**PLANNING COMMISSION MEETING
AGENDA
CITY OF WHITE BEAR LAKE, MINNESOTA**

- A. **Case No. 20-1-P:** A request by **321 Group LLC** for a preliminary plat, per Code Section 1402.020, to subdivide one parcel into 9 single-family residential lots on the property located at 1800 County Road E.

TO: Samantha Crosby, Planning & Zoning Coordinator

The Engineering Department reviewed the Civil Plans and Stormwater Drainage Report dated October 26, and received October 27, 2020, and have the following comments in **red text**. Comments in black text are from review comments dated September 18, 2020.

SHEET
C1.03

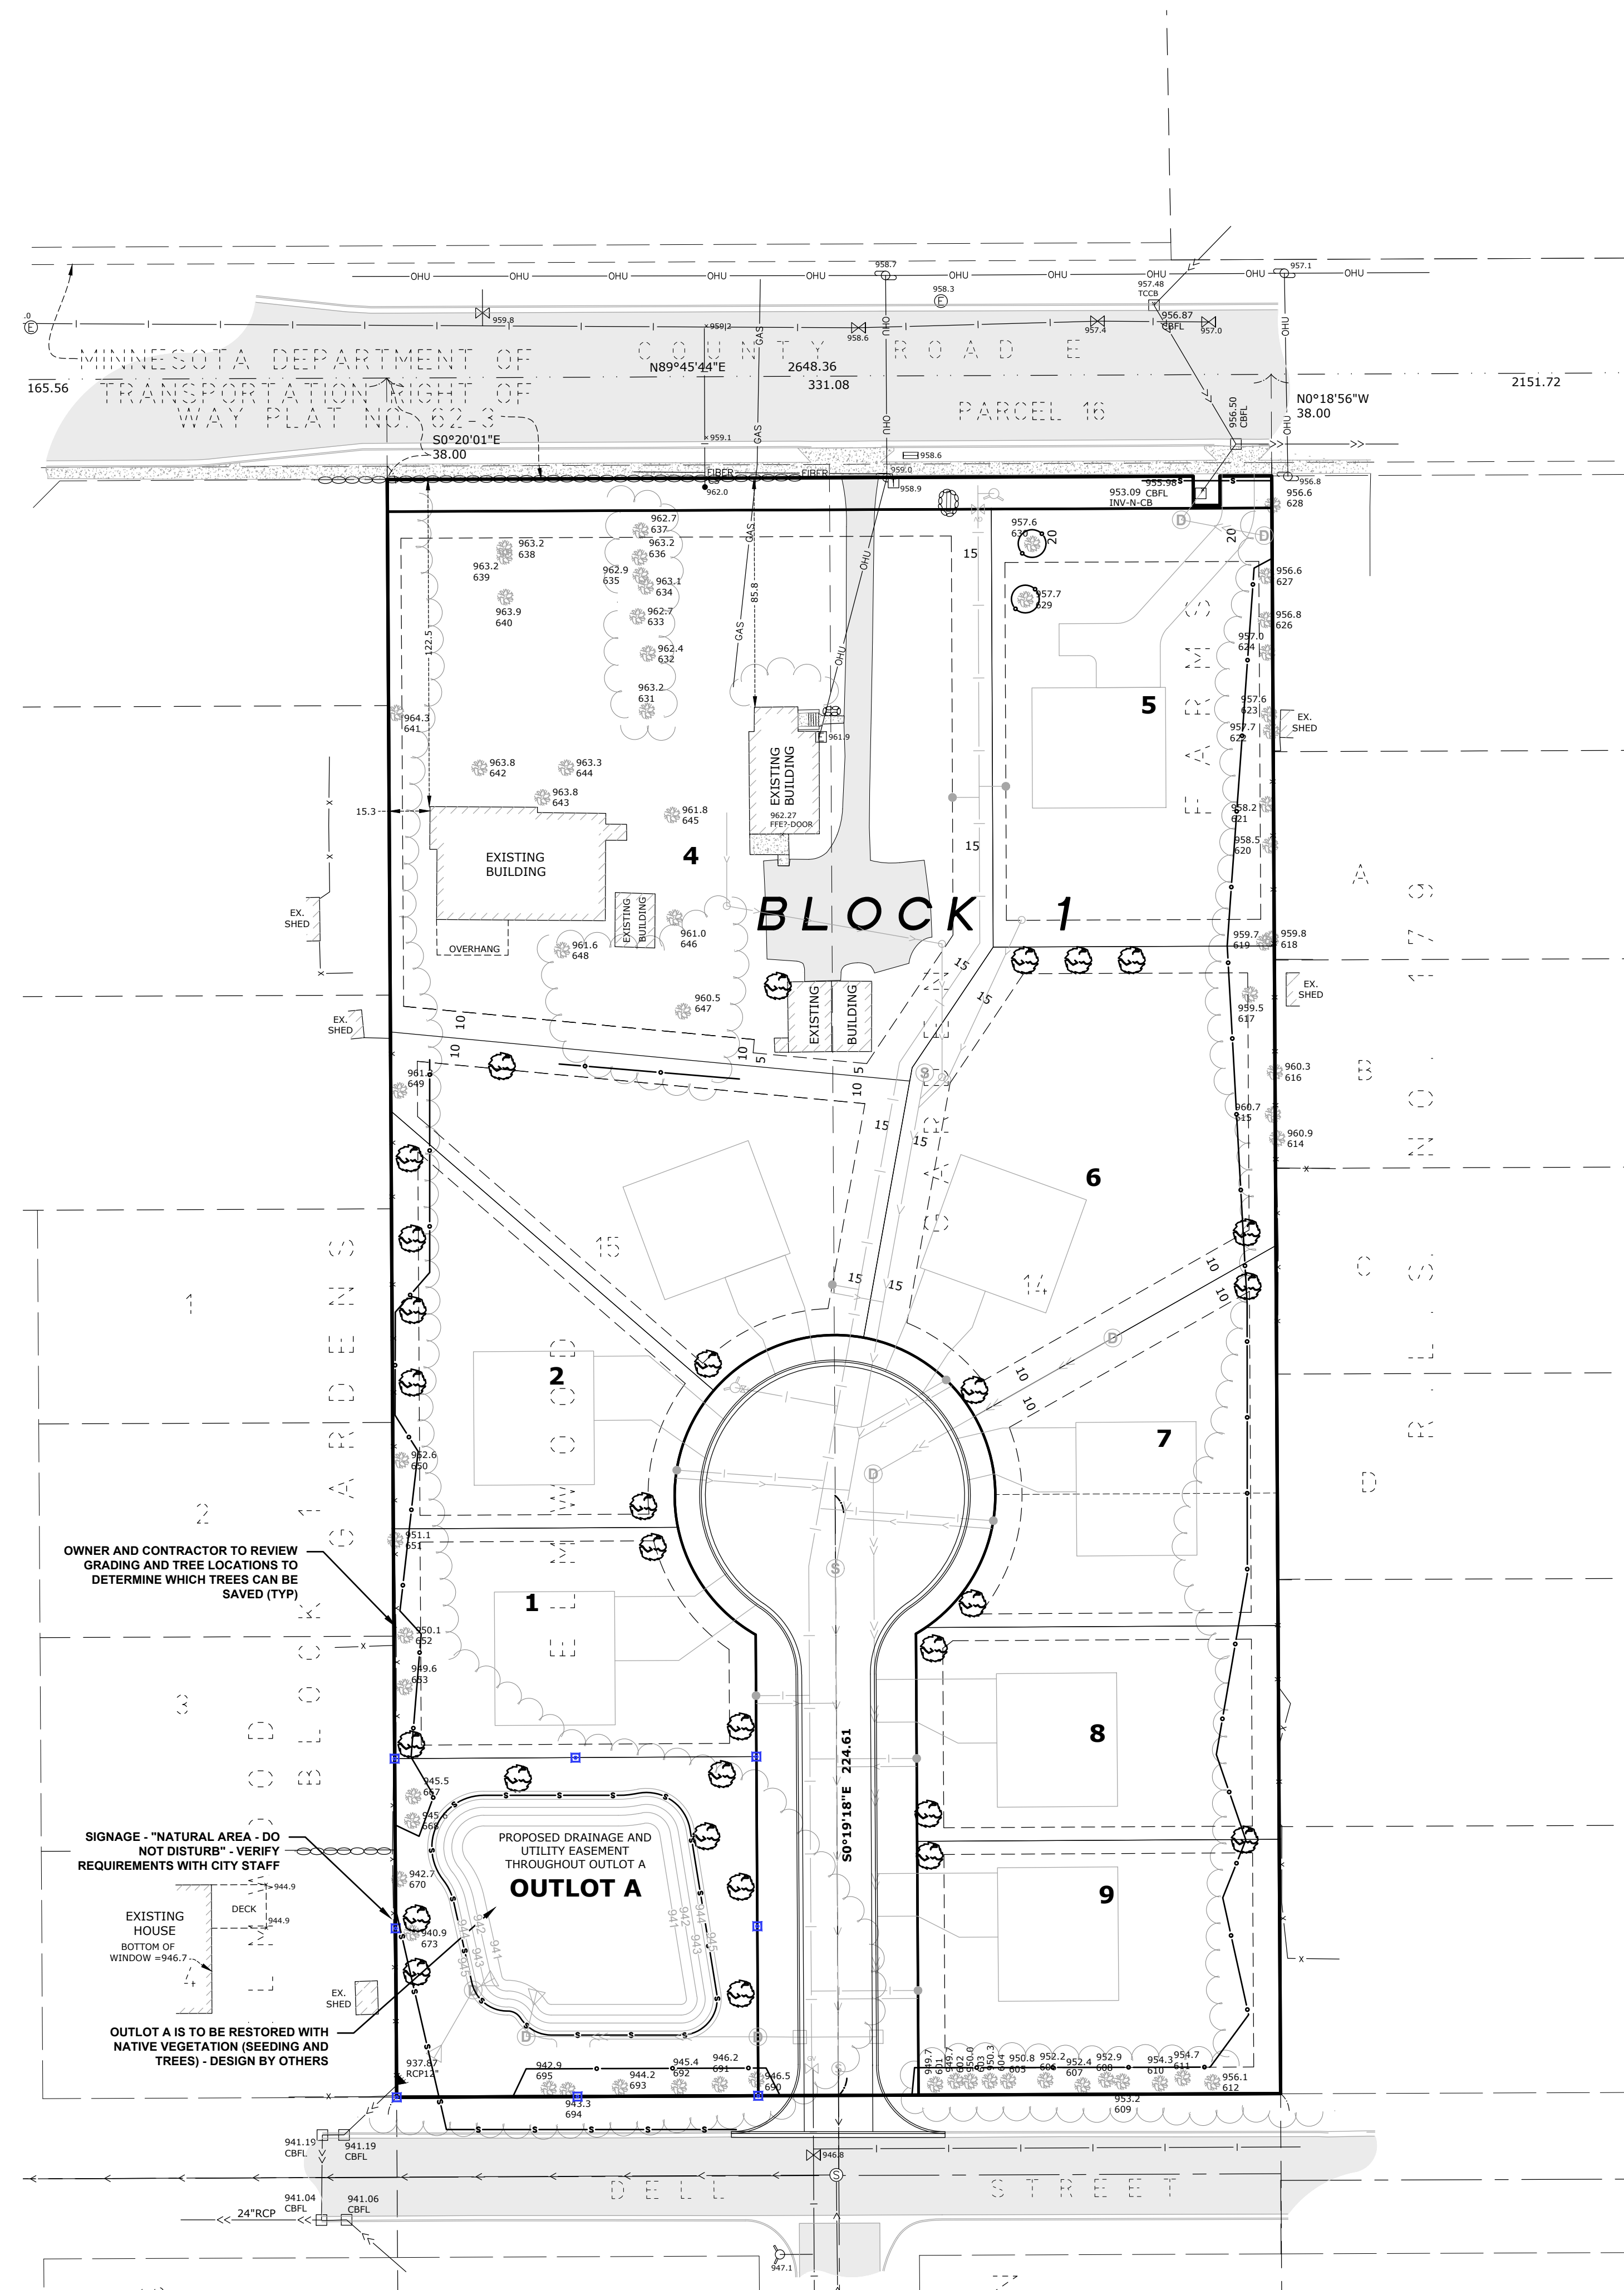
- 7) Add the additional tree protection fence from comment 17 on this plan sheet.

11/6/20: This item has been addressed. In addition, please call out tree protection fence with label, and label lot 3. Please correct Connie’s e-mail, see response to comment 6.
